SOUTHERN ENVIRONMENTAL LAW CENTER

October 1, 2019

RE: New information regarding the proposed landfill site for Oak Ridge Reservation Comprehensive Environmental Response, Compensation, and Liability Act Waste.

Figure 1. Site Characterization: Groundwater Levels.¹⁷

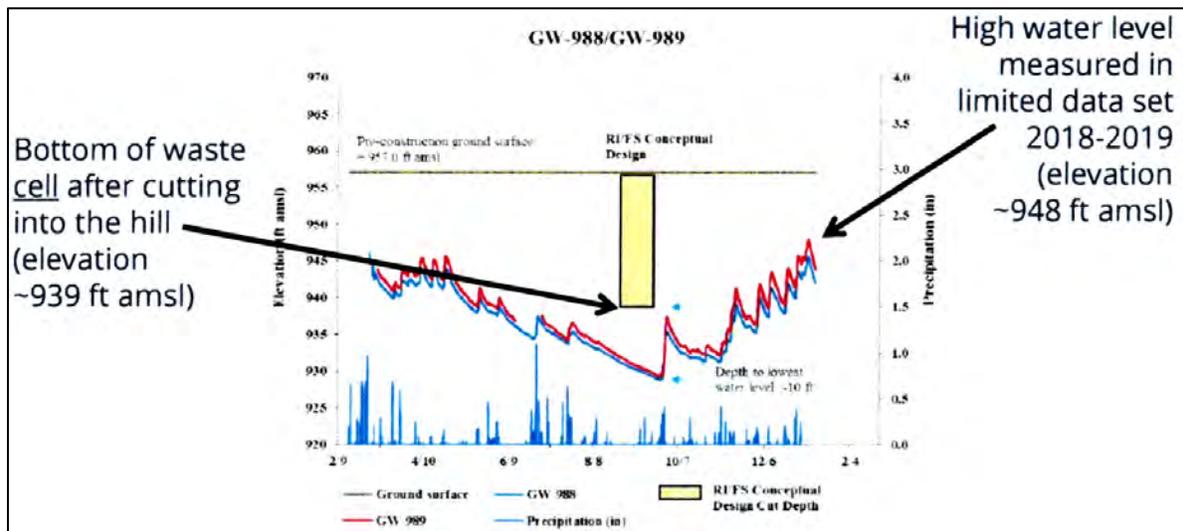
New groundwater information significantly changes the features of the remedy the Department has proposed: to construct a landfill that would taint a greenfield on the Oak Ridge Reservation (the Proposed Plan).¹¹ In the Proposed Plan, the Department claimed the location was the “most appropriate area on the [Oak Ridge Reservation] for locating an onsite disposal facility” in part due to its “groundwater flow conditions,” citing the “considerable amount of information” available about the subsurface and groundwater conditions in Bear Creek Valley.¹² At the time of the public comment period, the Department told the public that the landfill would maintain a “10 ft geologic buffer above seasonal high groundwater.”¹³ The Department said that “[r]esults of the Phase 1 site characterization confirm the acceptability of the [landfill] site for a new, low-level waste landfill and support final site selection.”¹⁴ However, recently released Technical Memorandum 2 reveals that groundwater levels at the site are significantly higher than originally anticipated and understood.¹⁵ According to the new groundwater information, a substantial portion of the landfill would sit below the water table.¹⁶ (Figure 1).

The newly revealed groundwater levels at Bear Creek Valley raise critical questions about the design and performance of the landfill as proposed. The U.S. Environmental Protection Agency’s (EPA) comments on Technical Memorandum 2 underline that the proposed landfill must have “a completely unsaturated clay geobuffer layer to demonstrate the protectiveness requirements necessary to obtain waivers.”¹⁸ However, the landfill as proposed would sit below the water table, and there is a substantial risk that waste would not be adequately contained.¹⁹ The Tennessee Department of Environment (TDEC) stated that Technical Memorandum 2 “raises significant questions about how [the Department] will support the contention that the [proposed landfill] site is acceptable.”²⁰ More explicitly, TDEC stated that Technical Memorandum 2 “makes it difficult to determine if the landfill can be constructed and operated in a manner that will meet the two CERCLA threshold criteria.”²¹ In the wake of this new information, the Department has not altered the Proposed Plan or given the public an opportunity to comment on the issues raised by this new information.
